SCOPE OF PROJECT CHANGES:

PERMIT DRAWINGS

CLARKSON RESIDENCE

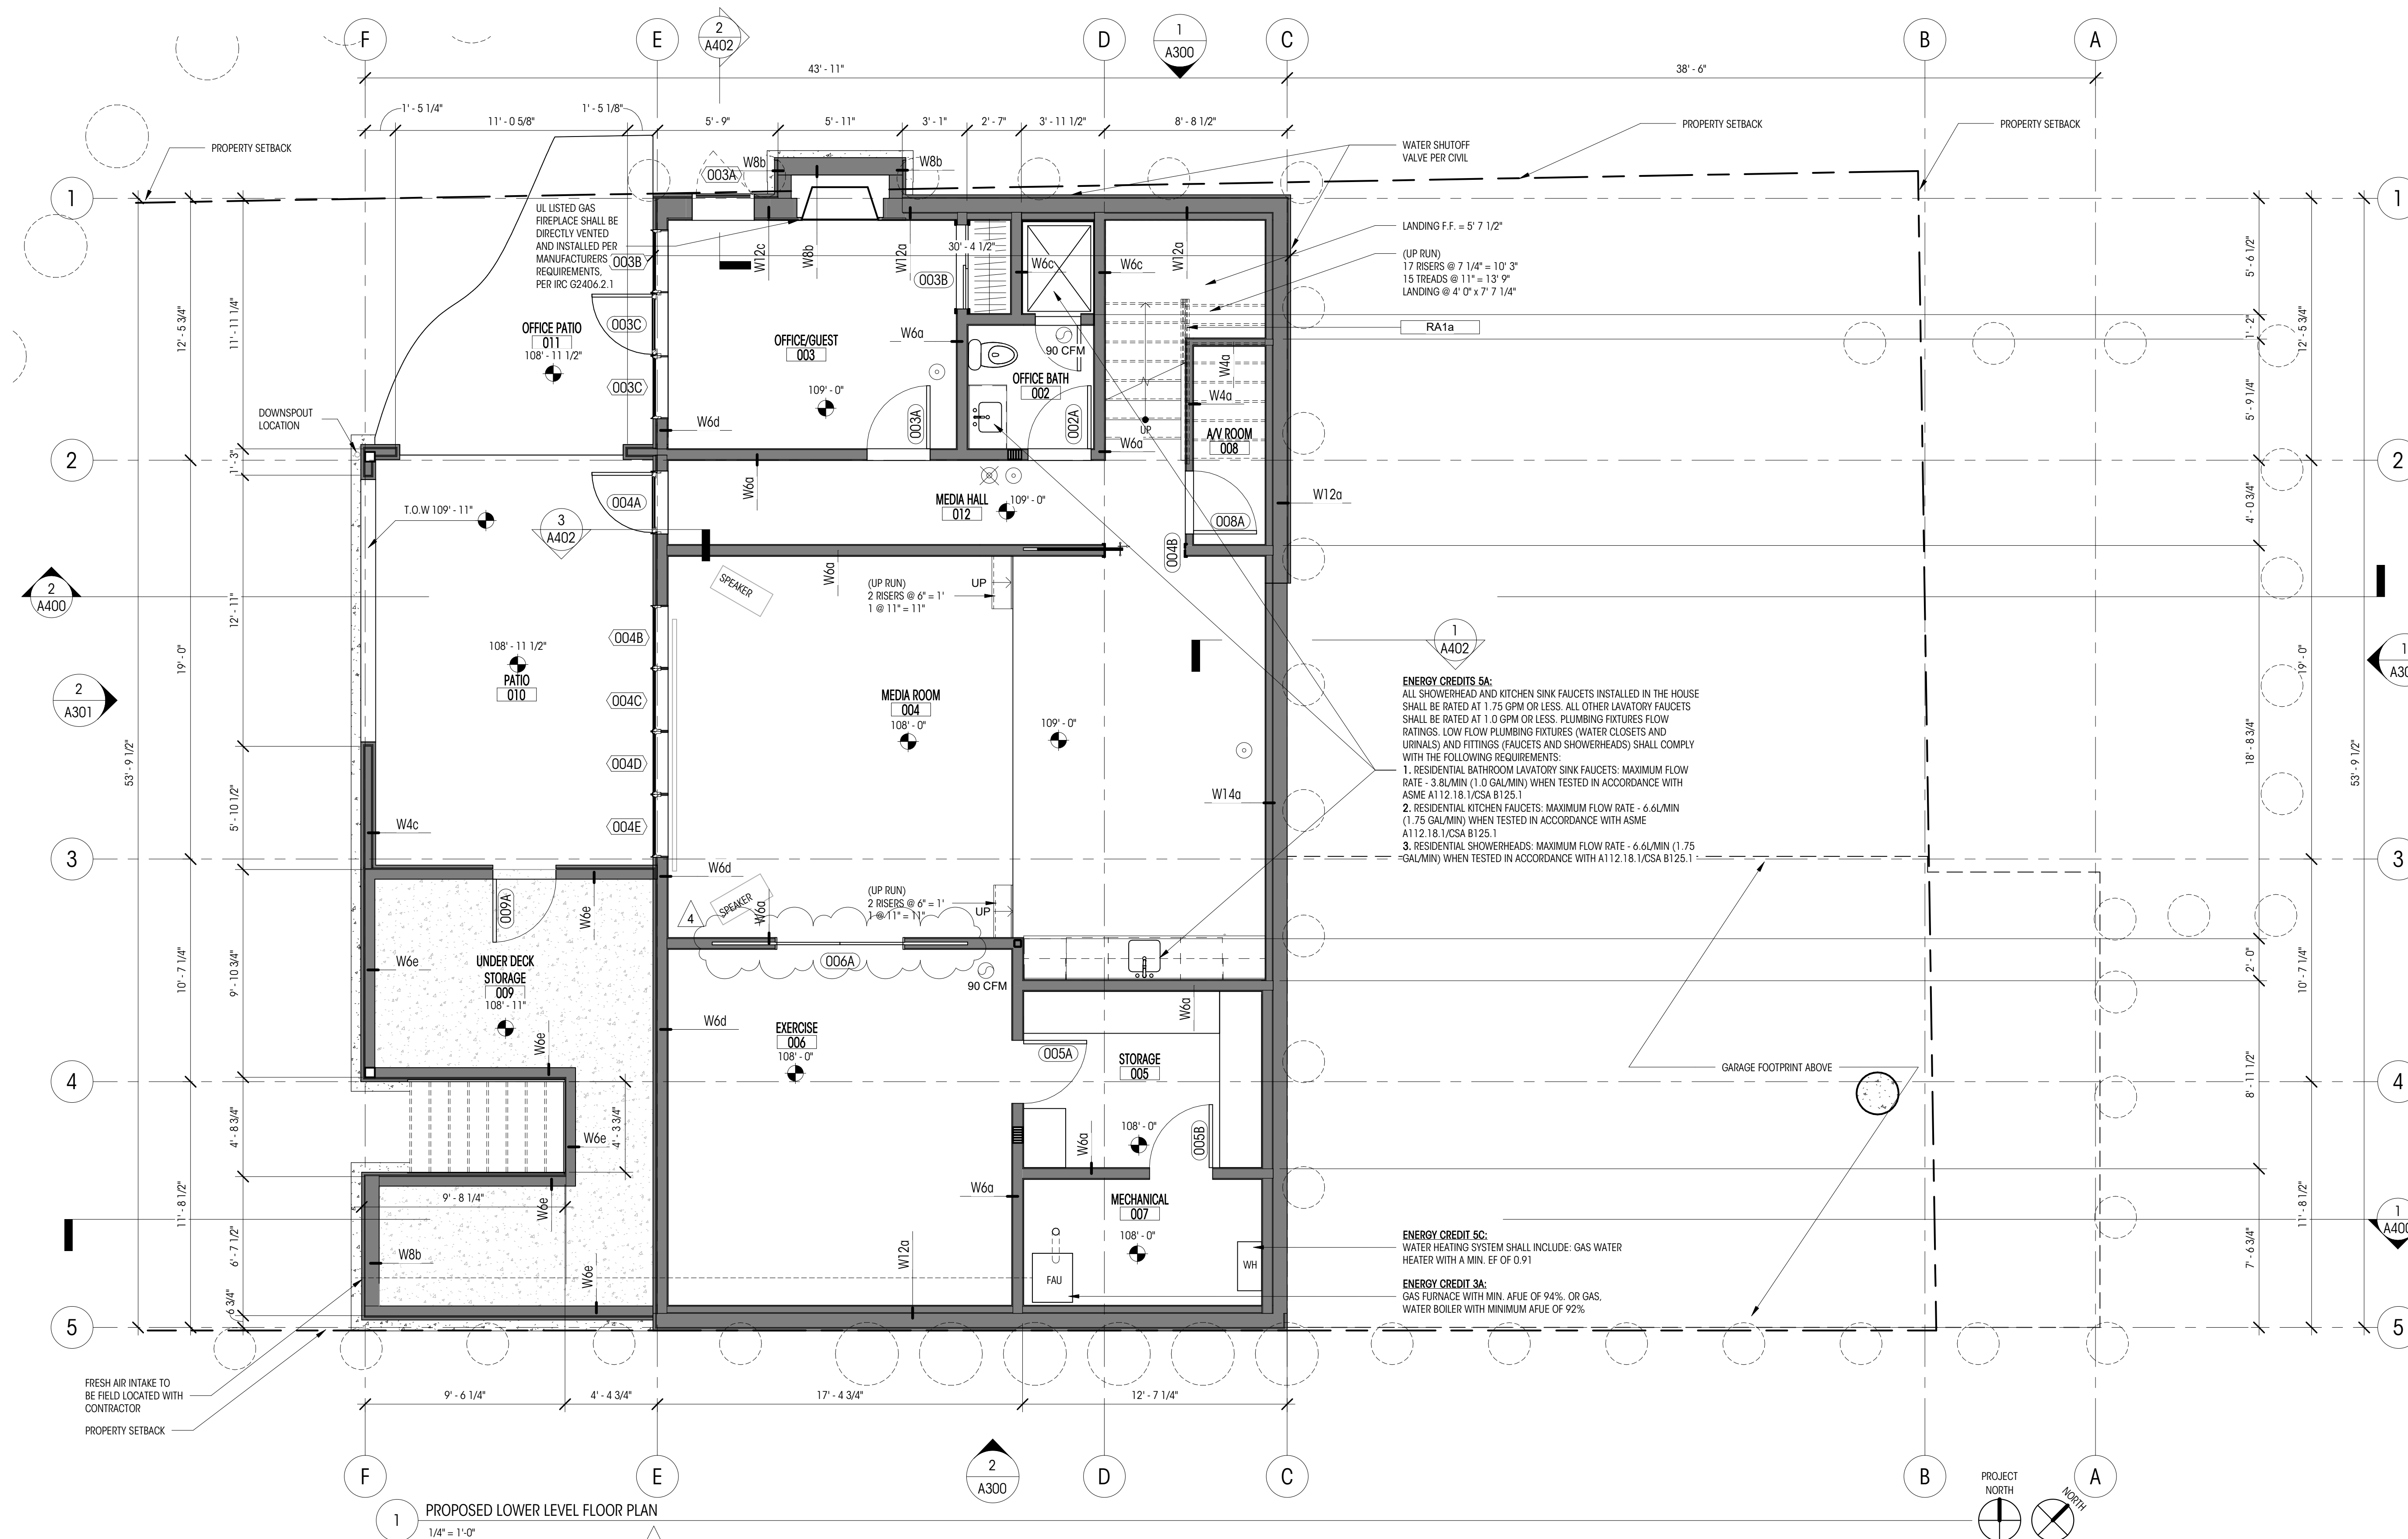
- NON-STRUCTURAL INTERIOR LAYOUT CHANGES TO BASEMENT LEVEL.
- ADDITION OF FIREPLACE AT BASEMENT LEVEL.
- ADDITION OF PATIO AT BASEMENT LEVEL.
- WINDOW SIZE & LOCATION CHANGES.
- EXTENDED WESTERN PATIO TO THE NORTH AND SOUTH
- LEVEL CHANGES: DRIVEWAY & GARAGE LEVEL DROP BY 12"; BASEMENT LEVEL DROP BY 12";
- CHANGE TO ABE AS A RESULT OF EXTENDED GARAGE AND EXTENDED COVERED DECK.
- CHANGES TO HARDSCAPE CALCULATIONS AS A RESULT OF SOIL STABILIZATION WALL, PATIO EXTENSION AND SITE STAIRS
- GRID LINES HAVE BEEN UPDATED FOR CLEAR EFFICIENT DIMENSIONS.

1 PROPOSED MAIN LEVEL FLOOR PLAN
1/4" = 1'-0"

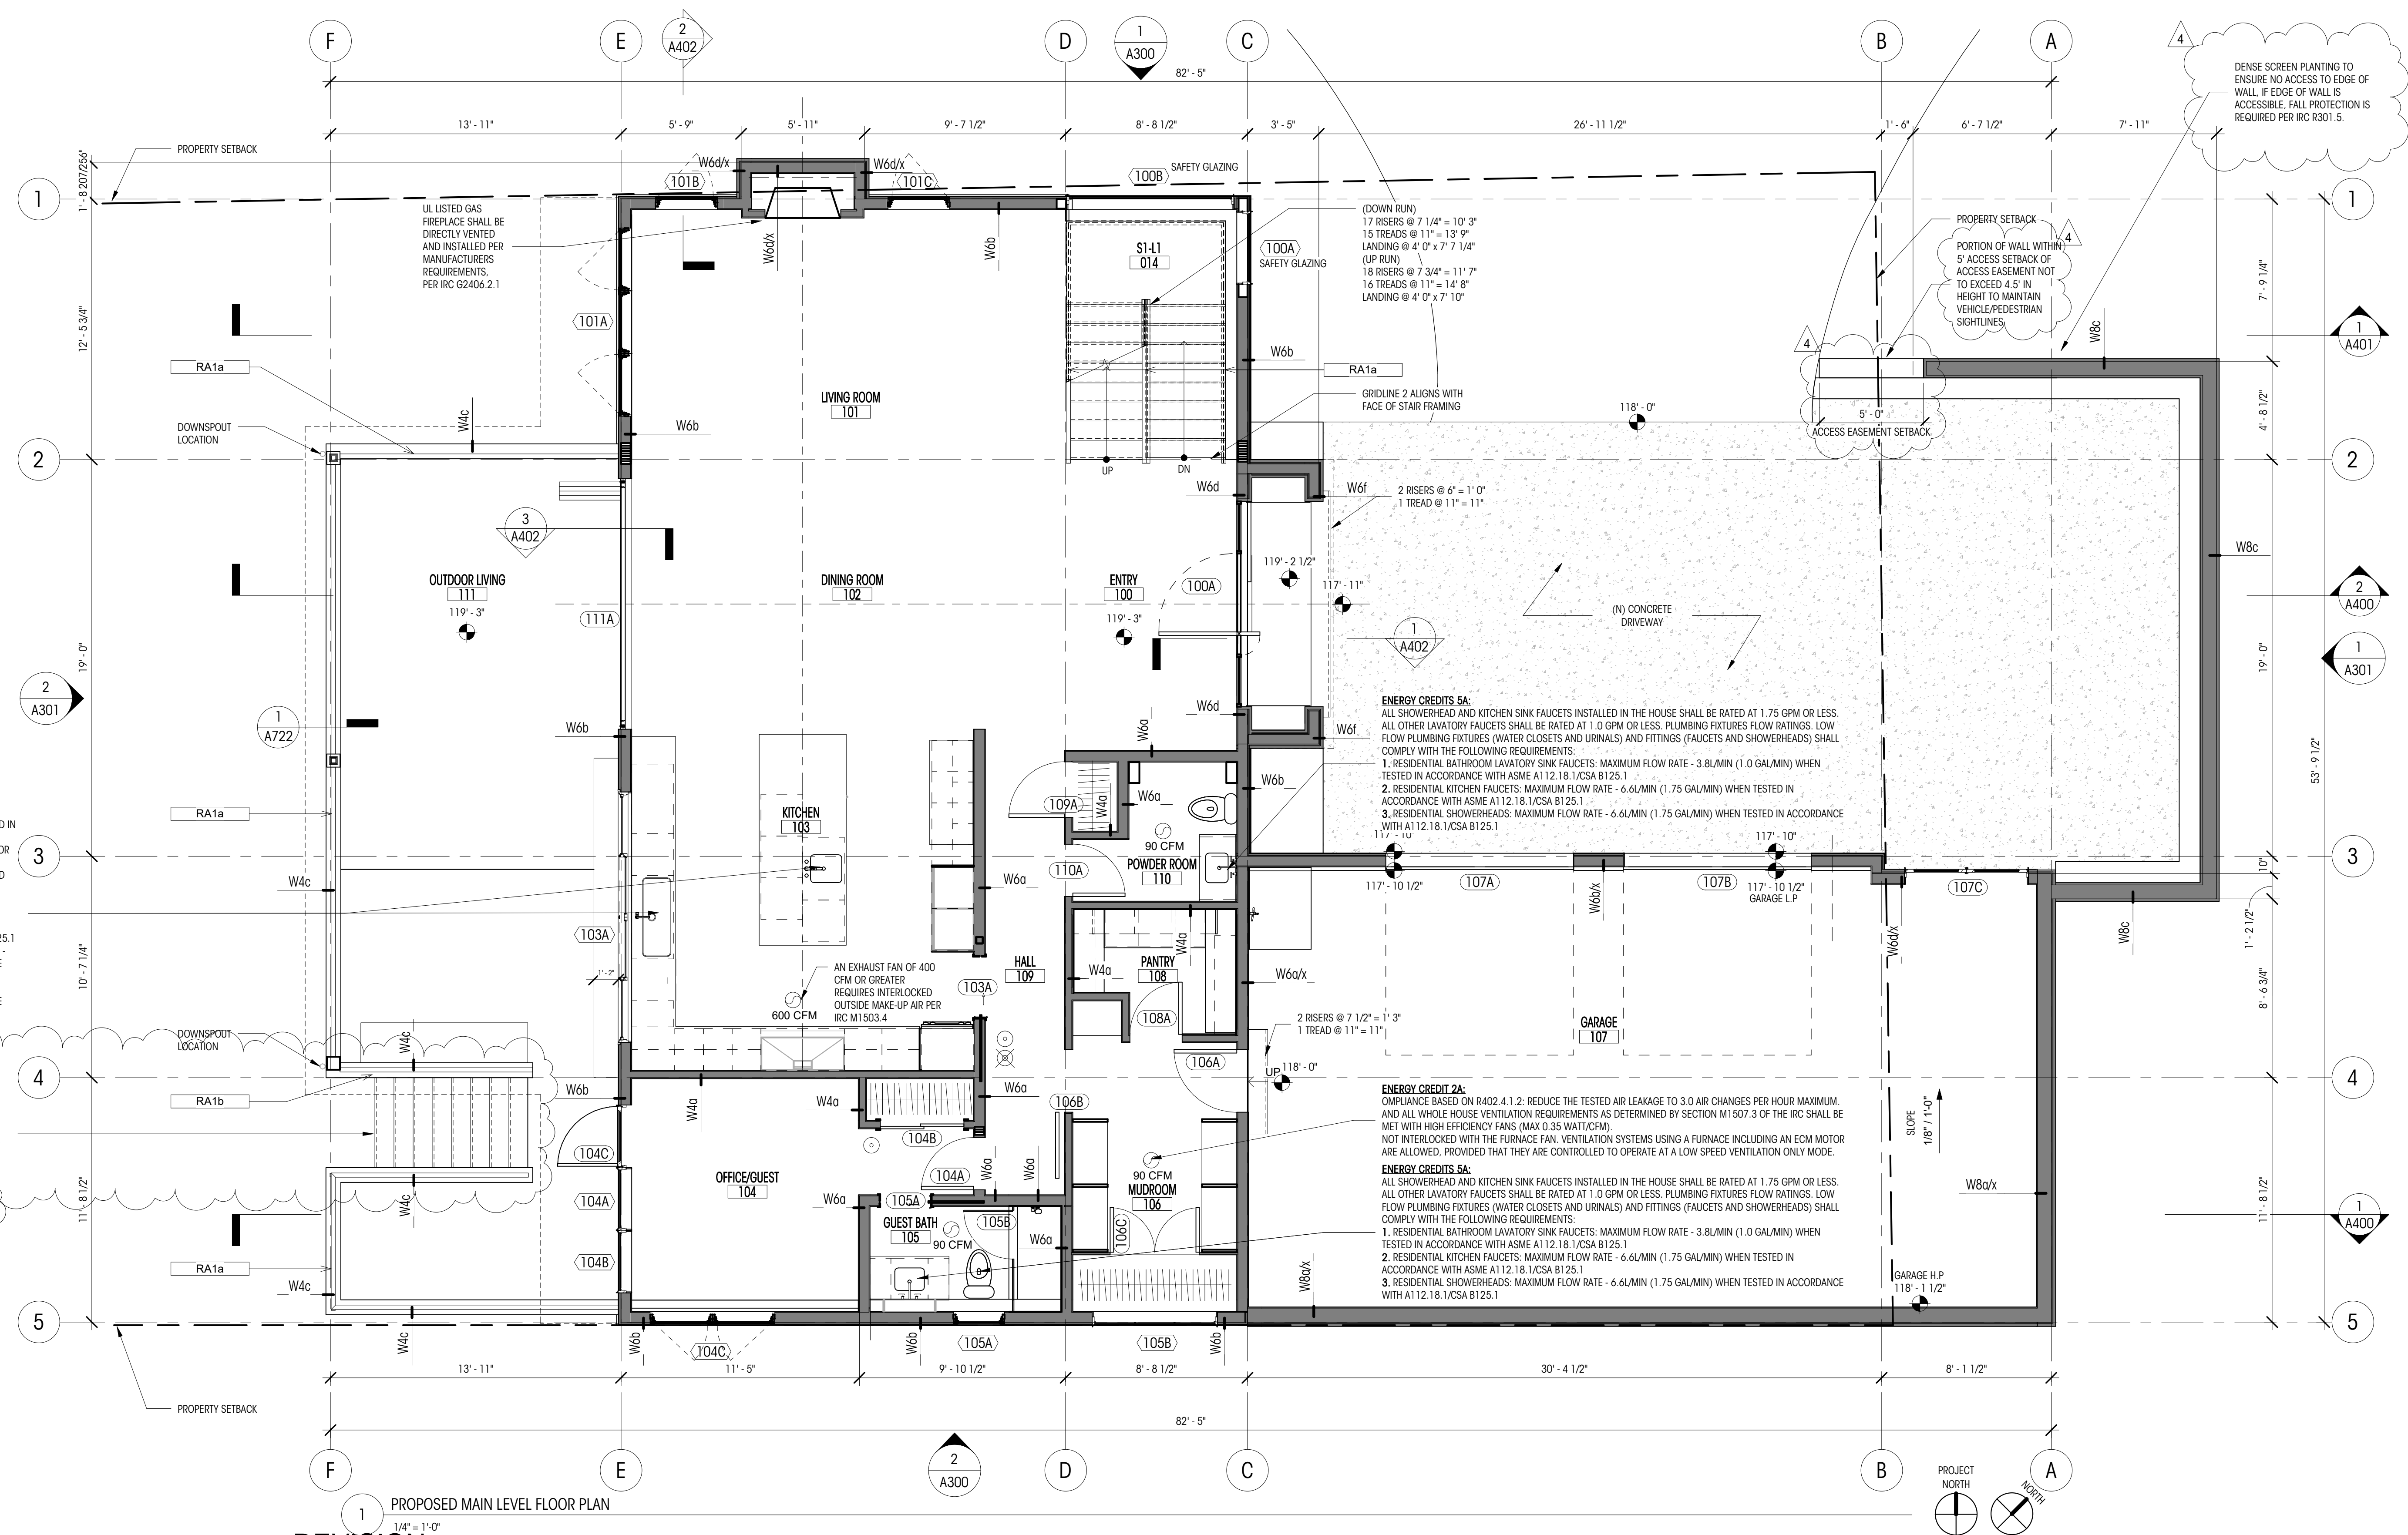
- INTERIOR LAYOUT CHANGES TO MAIN LEVEL
- ENTRY DESIGN CHANGE
- WINDOW SIZE & LOCATION CHANGES
- EXTENDED WESTERN PATIO TO THE NORTH AND SOUTH
- LEVEL CHANGES: DRIVEWAY & GARAGE LEVEL DROP BY 12"
- SHIFT OF PARKING RETAINING WALLS TO NORTH AND SOUTH
- EXTEND GARAGE EAST INTO FRONT YARD SETBACK AS ALLOWED BY CODE 19.02.040.D

1 PROPOSED UPPER LEVEL FLOOR PLAN
1/4" = 1'-0"

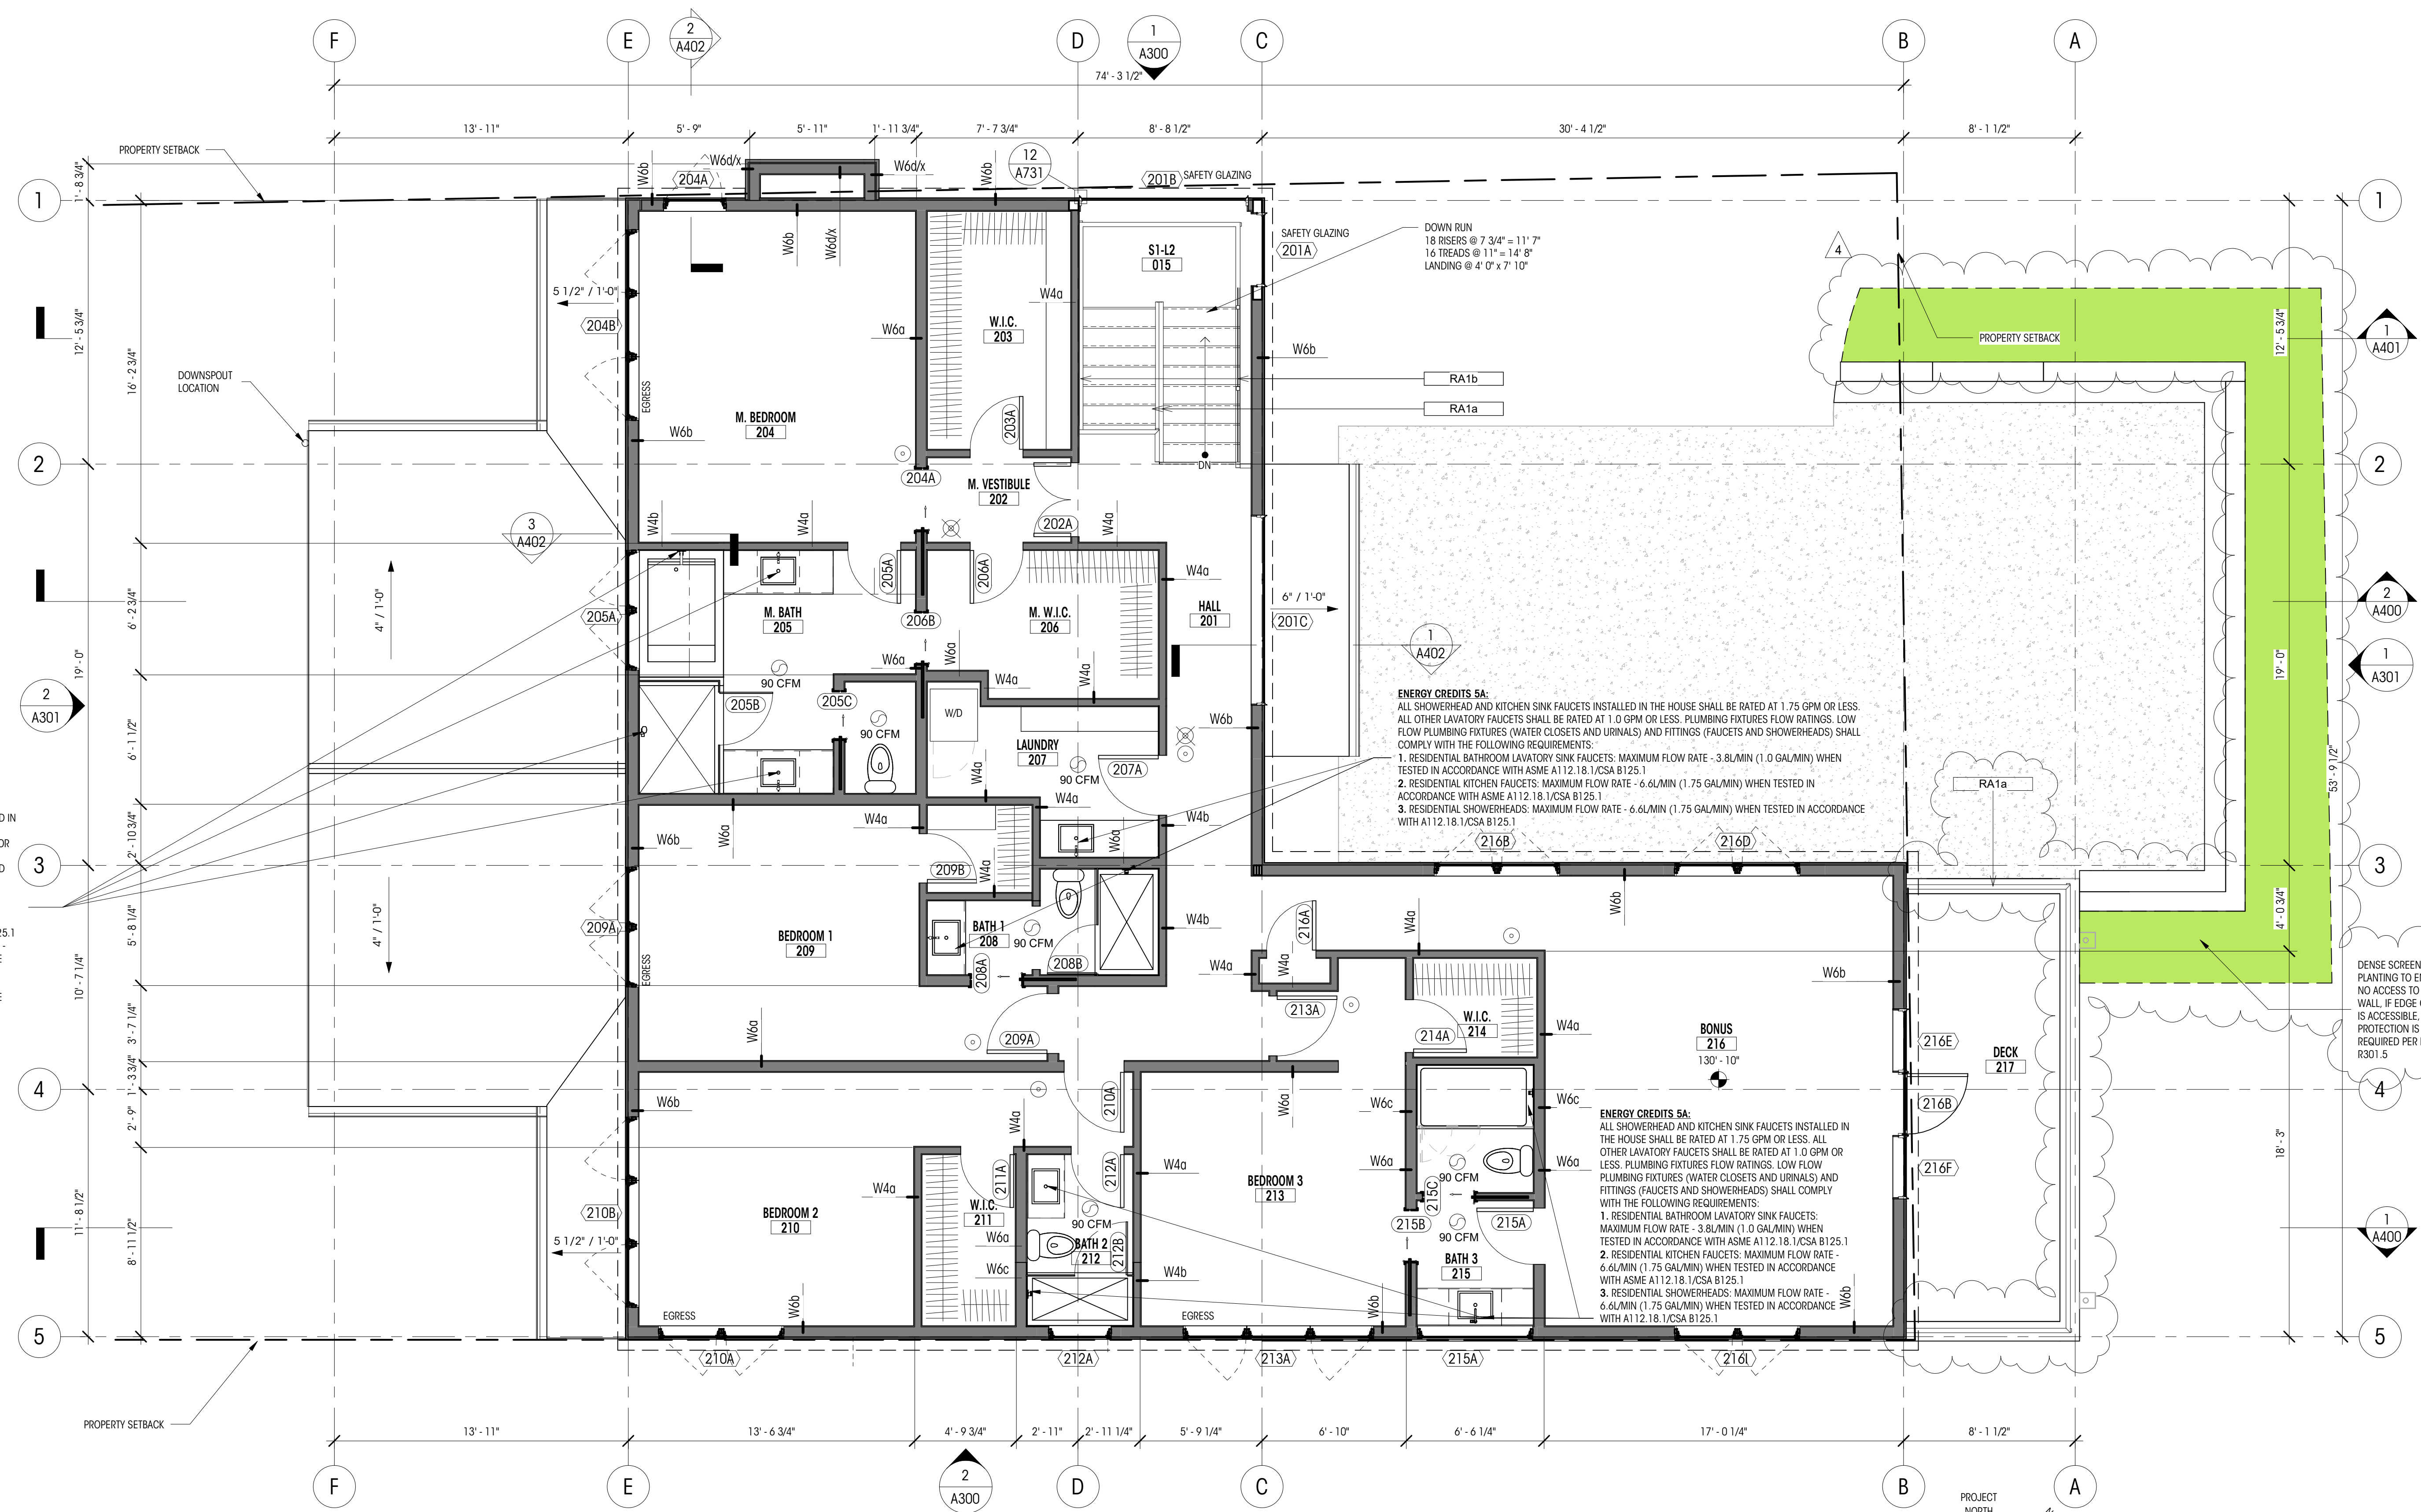
- INTERIOR LAYOUT CHANGES TO UPPER LEVEL.
- WINDOW SIZE & LOCATION CHANGES.
- EXTENDED WESTERN PATIO TO THE NORTH AND SOUTH.
- ELIMINATION OF UPPER LEVEL DECK, MAIN FLOOR DECK TO RECEIVE STANDARD GABLE ROOF.
- ADDED DORMERS AT UPPER LEVEL BONUS ROOM.
- OMISSION OF FIREPLACE AT UPPER LEVEL.
- SHIFT OF PARKING RETAINING WALLS TO NORTH AND SOUTH.
- ADDITION OF AWNING ROOFS OVER OFFICE & LIVING ROOM.
- EXTEND GARAGE EAST INTO FRONT YARD SETBACK AS ALLOWED BY CODE 19.02.040.D
- ADDED DECK AT ROOF OF THE EXTENDED GARAGE AREA.
- BATHROOM REVISIONS RESULT IN 1 ADDITIONAL TOILET AND 1 ADDITIONAL SHOWER
